Bicycle Master Plan Public Hearing Draft Work Session #4

Completed: 03/01/2018

Issue 12: Bikeway Recommendation between Capital Crescent Trail and the C&O Canal Towpath

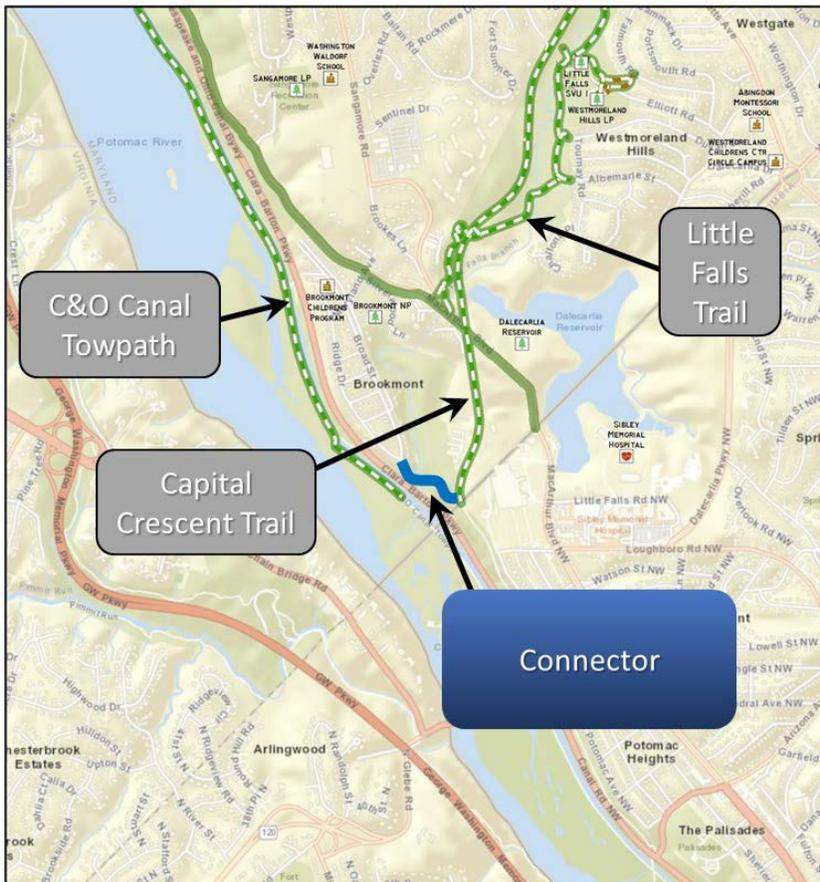
MCDOT recommends connecting the Capital Crescent Trail and the C&O Canal Towpath near the border with the District of Columbia by providing a short trail between the Capital Crescent Trail and the Broad Street in the Brookmont community (Comment #204). Bicyclists would then use an existing connection between Broad Street and the C&O Canal Towpath. Relevant pages of the plan are the Bethesda – Chevy Chase (West) map on page 242.

Staff Response: Staff recommends recognizing MCDOT's proposed trail between Broad Street and the Capital Crescent Trail but qualifying the recommendation to say that “The implementation of this proposal is contingent upon evaluation of potential impacts to park land. Further, it will be subject to

the avoid, minimize, mitigate and compensate policy adopted by the Planning Board in the 2017 Parks, Recreation and Open Space (PROS) plan”.

Issue 13: Bikeway Recommendation on Fernwood Road

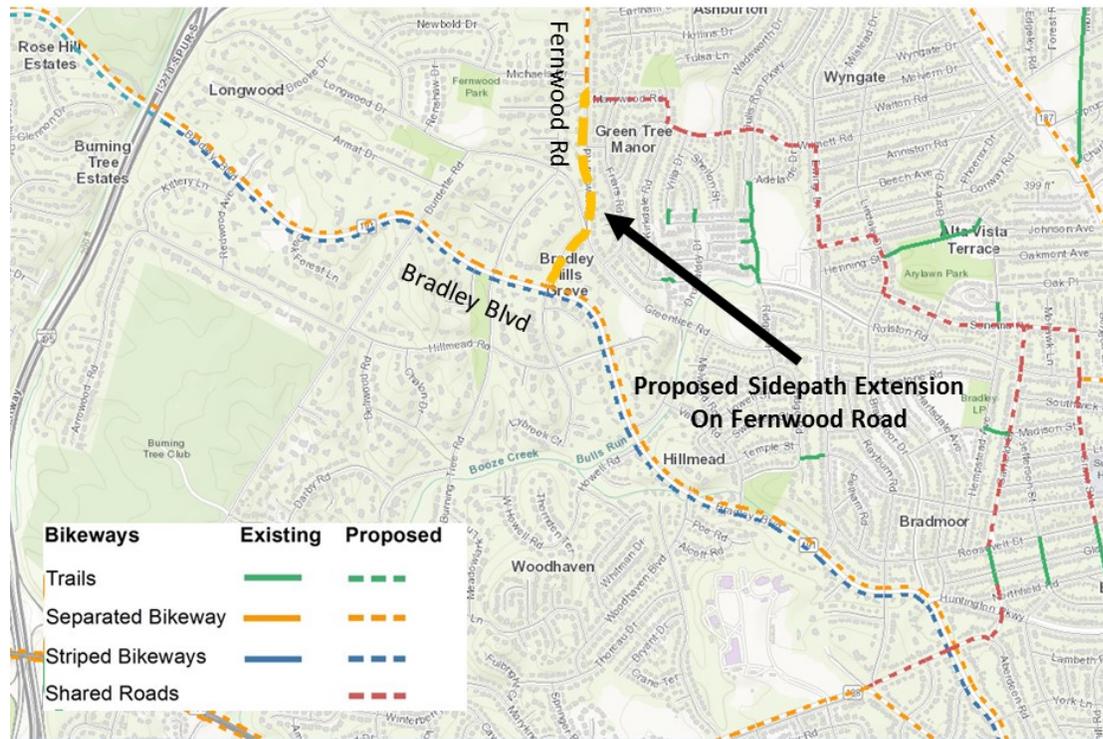
MCDOT commented that an extension of the Fernwood Road sidepath to Bradley Blvd should be considered. (Comment #206). Relevant pages of the plan are the Bethesda – Chevy Chase (West) map on page 242.

Staff Response: Staff recommends extending the Fernwood Road sidepath to Bradley Blvd.

Issue 15: Bikeway Recommendation on Capitol View Avenue

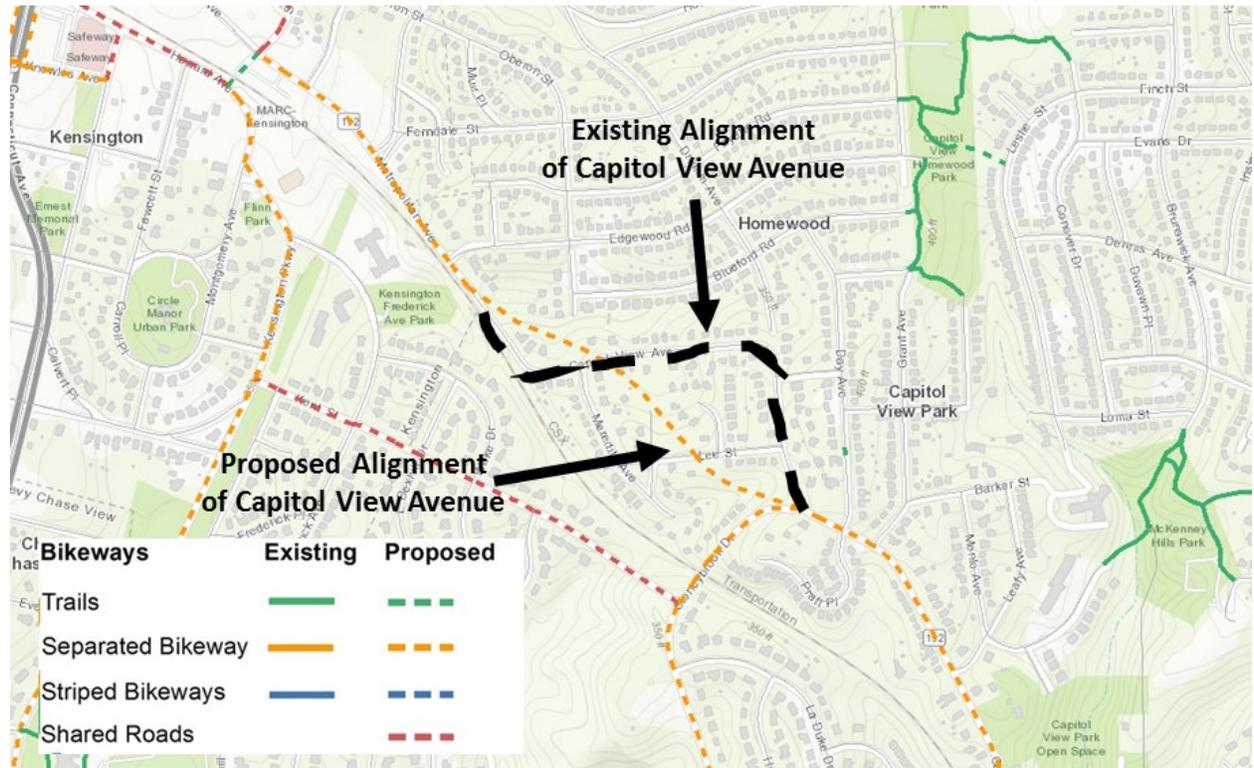
Ulla Buchholz of the Capitol View Avenue Neighborhood Association commented that the proposed bikeway on Capitol View Avenue should follow the existing road alignment, not the alignment in the 1982 Capitol View Sector Plan, which is infeasible (Comment #329). The relevant section of the plan is the Kensington - Wheaton map on page 292.

Staff Response: The 1982 Capitol View Sector Plan recommends straightening Capitol View Avenue. The proposed sidepath follows the master-planned alignment of the road. Staff believes that the sidepath should continue to be located along the master-planned alignment of the road. A future update to the 1982 Capitol View Sector Plan would likely consider whether to retain the master-planned alignment of Capitol View Avenue. If the master-planned alignment is modified, the bikeway would need to be modified as well.

Issue 16: Bikeway Recommendation on US 29 Ramp and Prosperity Drive

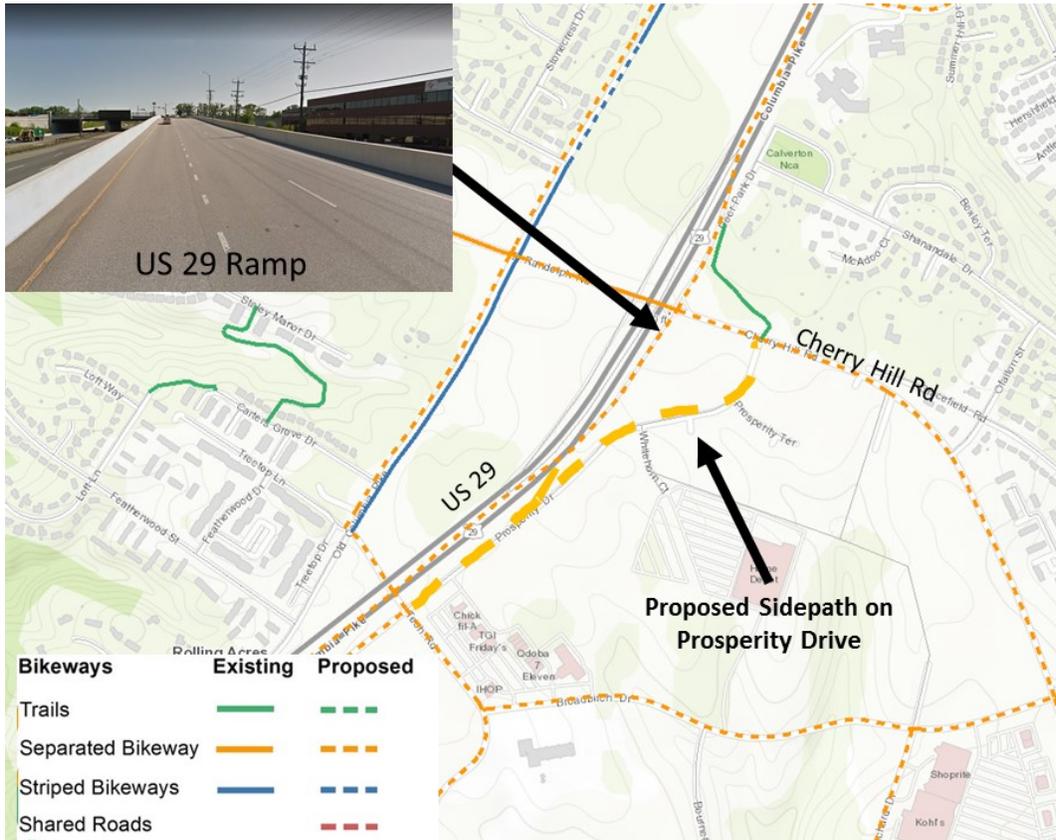
The Bicycle Master Plan recommends a sidepath on the east side of the US 29 northbound ramp to Cherry Hill Road (see White Oak map on page 364 of the plan). This will be costly and difficult to implement. This bikeway should be replaced by a sidepath on the west side of Prosperity Drive, which connects to an existing trail on the north side of Cherry Hill Road.

Issue 17: Bikeway Recommendation on Jones Mill Road

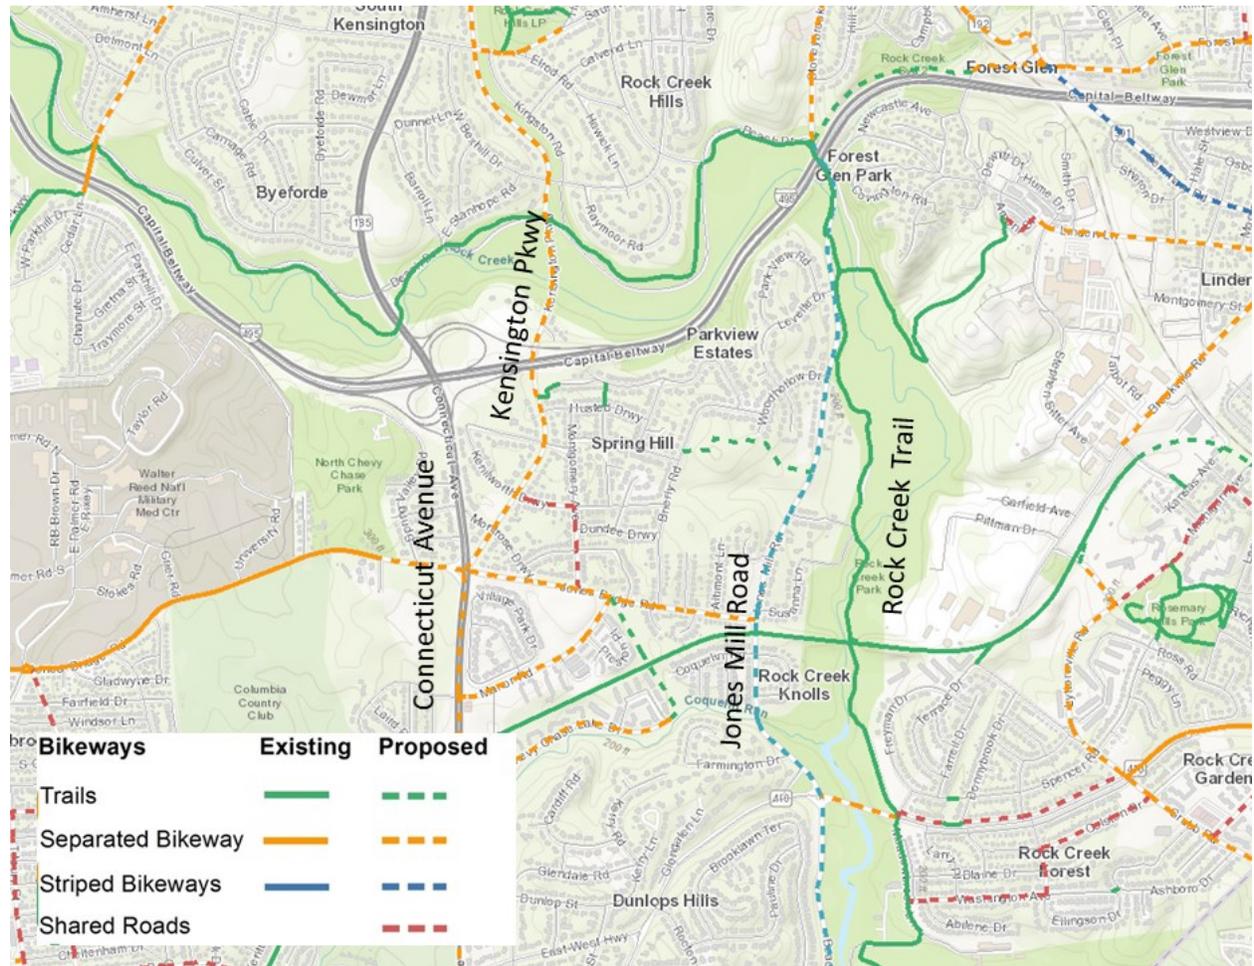
MCDOT questioned why Jones Mill Road is recommended to have “bikeable shoulders,” which are not a low-stress bikeway (Comment #217). The relevant section of the plan is the Bethesda – Chevy Chase (East) map on page 236 and the Chevy Chase Lake map on page 248.

Staff Response: Staff did not recommend a low-stress bikeway on Jones Mill Road because it is a very constrained environment, is heavily used by bicyclists who prefer to ride in the road and there are parallel low-stress bikeways, including the Rock Creek Trail and the proposed separated bikeways along Kensington Parkway and Connecticut Avenue.

Issue 18: Connections to C&O Canal Trail

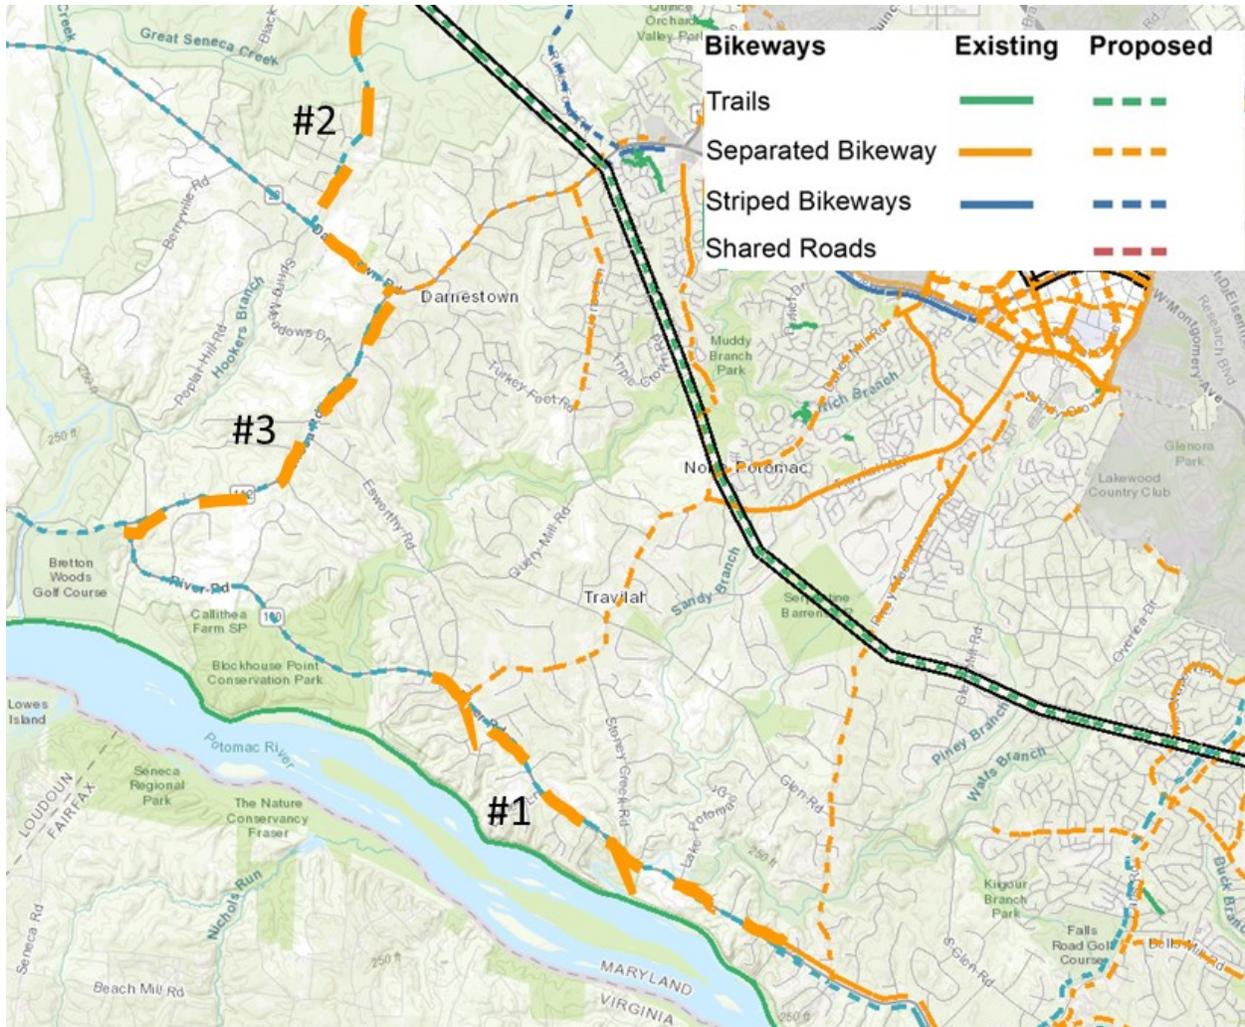
Joe Allen stated that the plan includes insufficient connectivity to C&O Canal Towpath. He recommends:

1. Extending the River Road sidepath to Pennyfield Lock Road.
2. Extending the sidepath on Germantown Road and Darnestown Road connecting the Germantown - Burtonsville Breezeway to Seneca Road.
3. Adding a sidepath on Seneca Road and River Road connecting Darnestown Road to Violettes Lock Road (Comment #374).

Staff Response: Staff recommends extending the sidepath on River Road to Seneca Road (#1 above). We disagree with adding sidepaths on Germantown Road, Darnestown Road and Seneca Road, as these would substantially change the rural character of these roads and the demand is likely to be low.
